ADIJ Report (2015.0805, KY)

- Before studying the possible tunnel layout for the conventional source, the tunnel for the undulator source must be discussed in some more detail than in the TDR.
- Okugi-san reviewed the undulator source and studied the possible tunnel configuration, including
 - Linac hardware (NC, SC and quads) based on TDR
 - Tunnel in NC linac region
 - Distribution of refrigerator
 - Optics in undulator region with quads
 - Optics and loading compensation of energy compressor
 - Chicane for timing adjustment

Suggestion for the tunnel in NC linac region

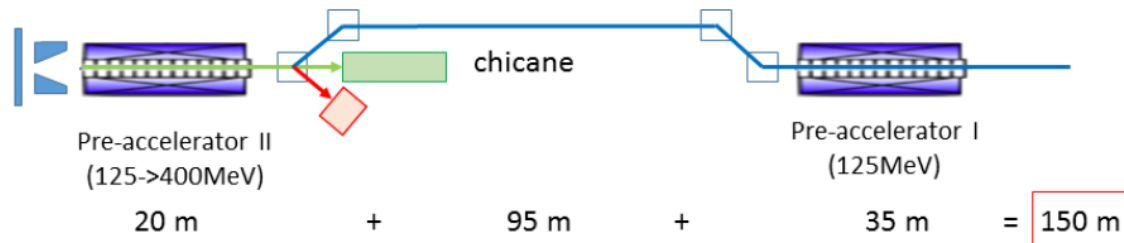
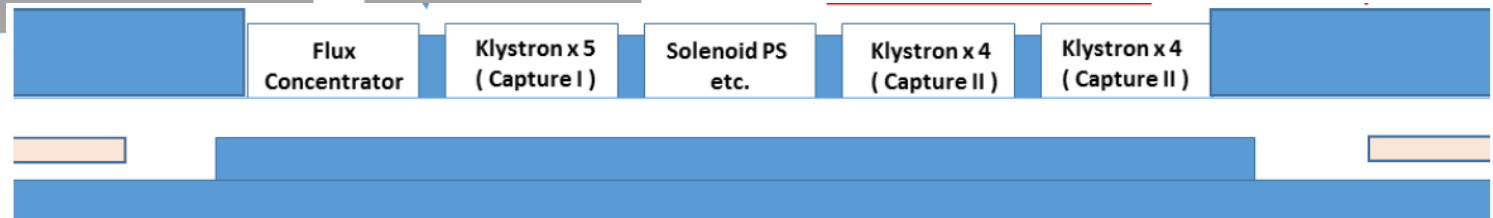
Width extension needed
(on top of linac tunnel size)
5m(w) x 3m (h) x 150m (L)

Path Length Aduster

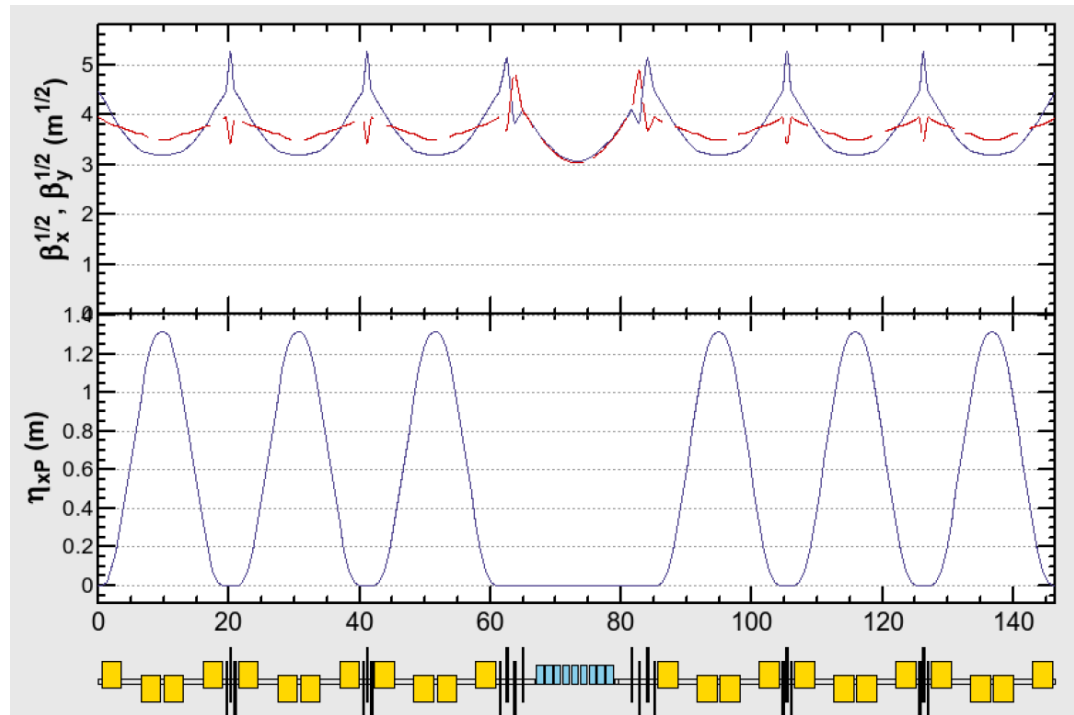
- Better to place after the energy compressor (minimal effects on longitudinal phase space)
- Width 1.2 meters, length $\sim 60\text{m}$ (same structure as the energy compressor)
- Adjustment range 0 to 68cm

Layout Summary

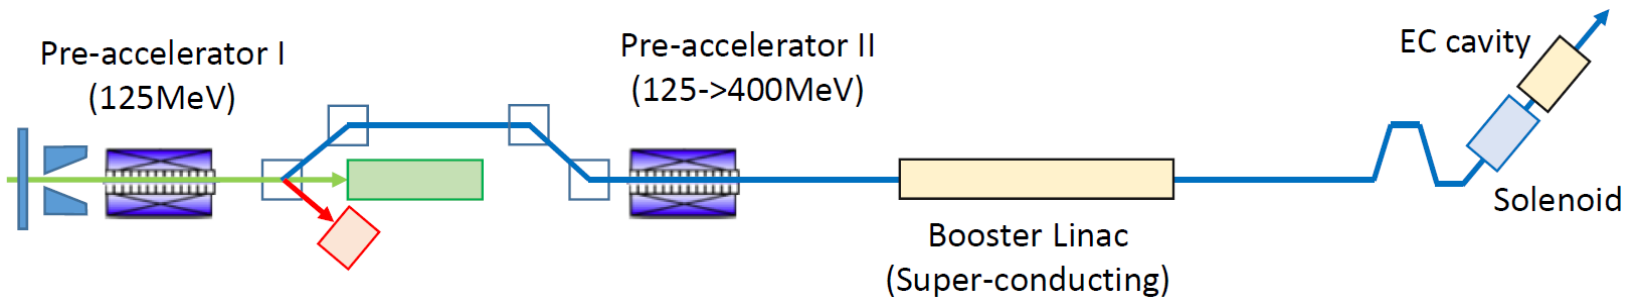
- TDR

- Possible revision

- “High Energy Transport Line” is, perhaps, long enough to accommodate e-Driven source.
